Product Change Notification

Change Notification #: 106322 - 00
Change Title: Intel NetStructure® MPCHC0001 14U
Chassis, PCN 106322-00, Product Design, Fan
Tray PCB change
Date of Publication: May 11, 2006

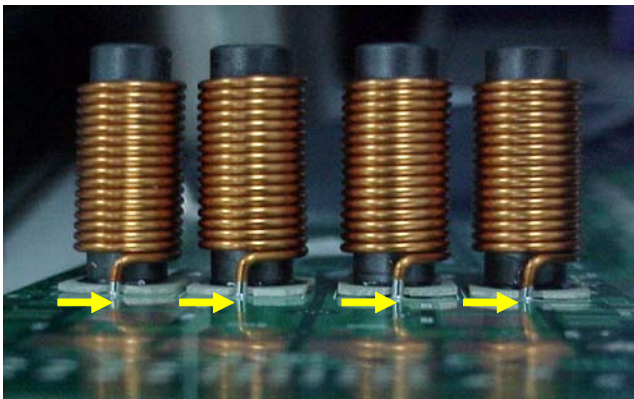
Fan Tray Board Inductor change and base added to improve manufacturing yield, as shown below.

Fan Tray assembly # will change from C94944-005 to C94944-006, Fan PBA from A95800-502 to A95800-503.
